Reply on RC2

Author comment on "Cost-benefit analysis of coastal flood defence measures in the North Adriatic Sea" by Mattia Amadio et al., Nat. Hazards Earth Syst. Sci. Discuss.,
<https://doi.org/10.5194/nhess-2020-414-AC2>, 2021

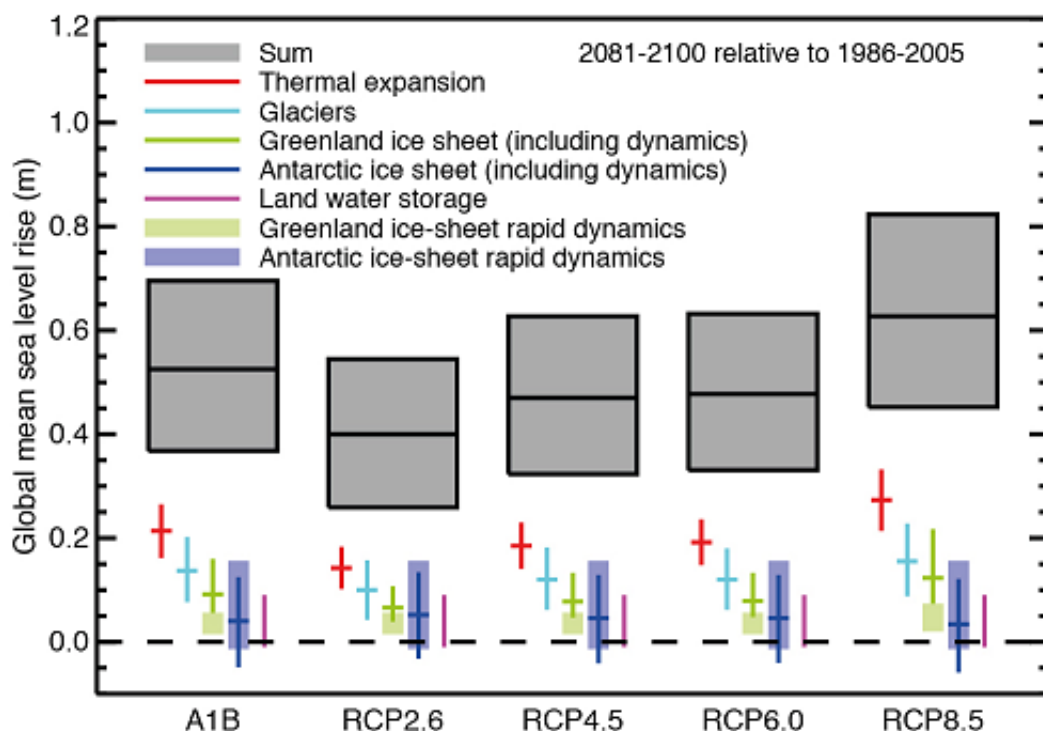
Line150: The authors used RCP4.5 for the future projections of SLR. It would be interesting to see what happens with RCP8.5.

- Thank you for this suggestion. It would have been interesting to explore additional SLR scenarios, however the scenario analysis was constrained due to time and funding limitations, which in turn depend on the preferences of the stakeholders. As a result, it has been agreed with the Municipality of Rimini to simulate only one RCP scenario (RCP 4.5, selected as the “average”), but to consider a wider range of flood probabilities in term of return periods (i.e. 1, 10, 100, and 250). We think the one scenario that could be added in future work to extend recommendations is the RCP 8.5 at 2100, as the same scenario at 2050 does not differ significantly in terms of global SLR with respect to the RCP 4.5, while the scenario RCP 6.0 doesn’t differ in terms of SLR significantly also at 2100.

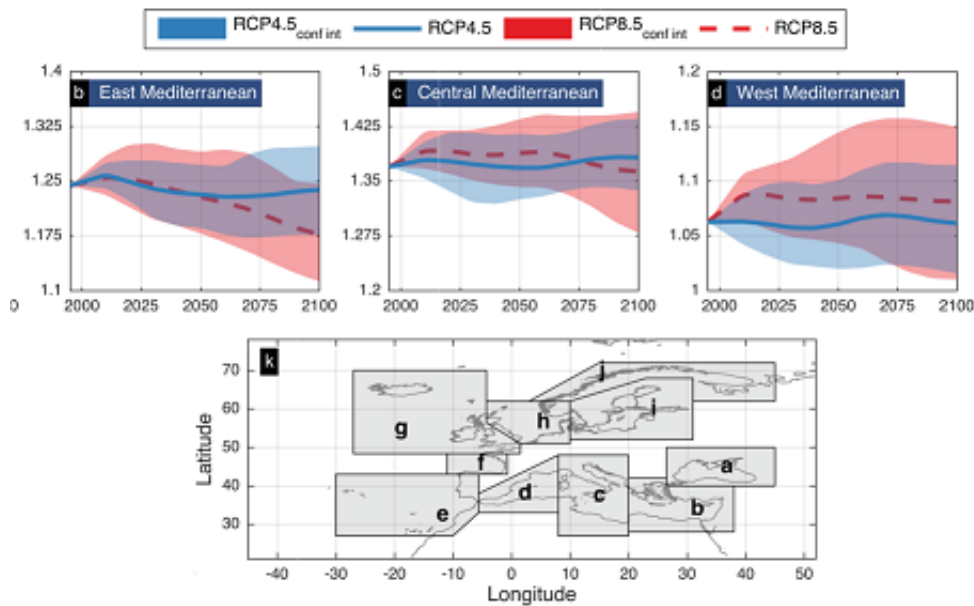
Line 150-152: Moreover, IPCC AR5 SLR projections give more local projected values of SLR. Apart from using a generic Global Mean Sea Level rise projection for the Mediterranean area, it would make more sense to account for more regional/local SLR values at specific coastal areas (as in IPCC AR5).

- Thank you for your valuable comment. We believe that in our analysis we do account for both local SLR historical observations at coast and specific downscaled projections for the central mediterranean basin. We have taken into consideration your comment and have amended par 3.3 to address these points more clearly:

We believe the dataset obtained from "Vousdoukas et al (2017) - Extreme sea levels on the rise along Europe's coasts" currently represents the best SLR estimate available for EU countries in alignment with the RCP framework:

Projections of RSLR indicate a statistically significant increase in MSL along the entire European coastline. The average RSLR across Europe is projected around 21 and 24 cm by the 2050s under RCP4.5 and RCP8.5, respectively. RSLR is projected to accelerate during the present century under both RCPs, reaching 53 and 77 cm by the year 2100 [...]. The RSLR projections show higher model agreement for the Mediterranean Sea and the Atlantic coast [...].
